addendum

4

Draper Prison Vocational Training Center

ajc architects project #: 0502 dfcm project #: 04256100

Specification Section 08331 and revised sheet AS102

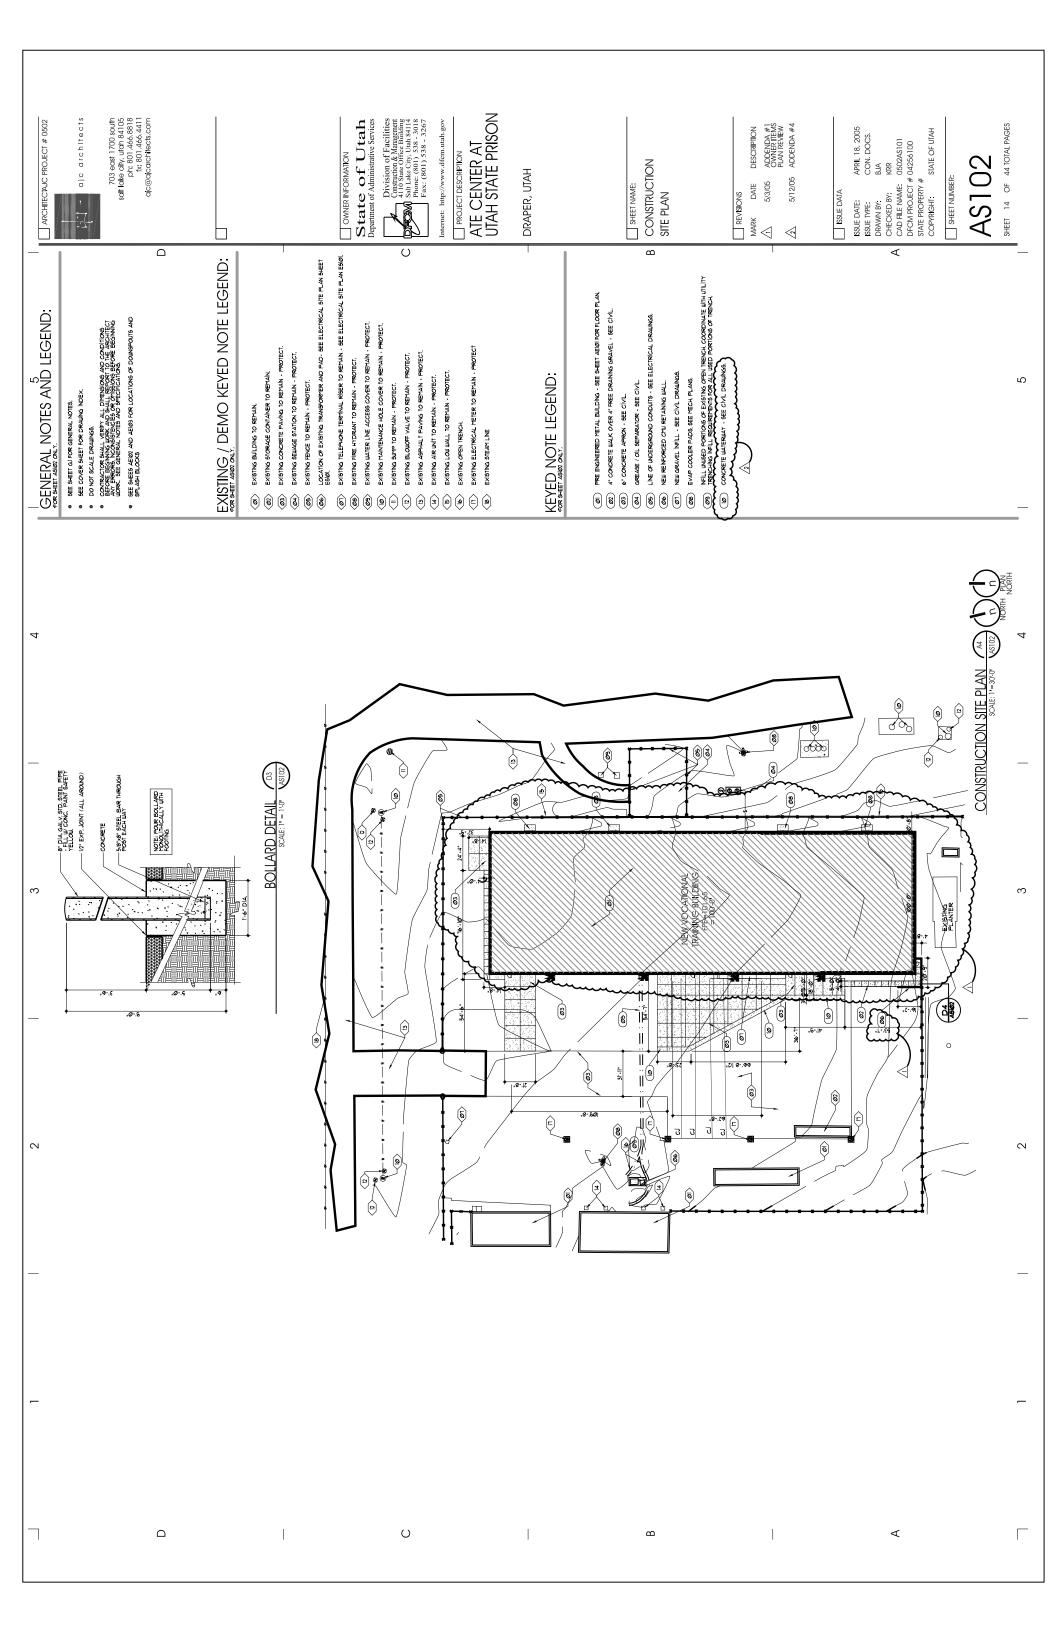
- Item 3: Millwork in Rest Rooms #111 and #112 to have plastic laminate counter tops (reference detail A5 sheet AE502).
- Item 4: See attached revised sheet AS102 for extent of new concrete paving and waterway. Sheet AS102 has been revised to match Civil Drawings as issued in Addendum #1 dated May 3, 2005.
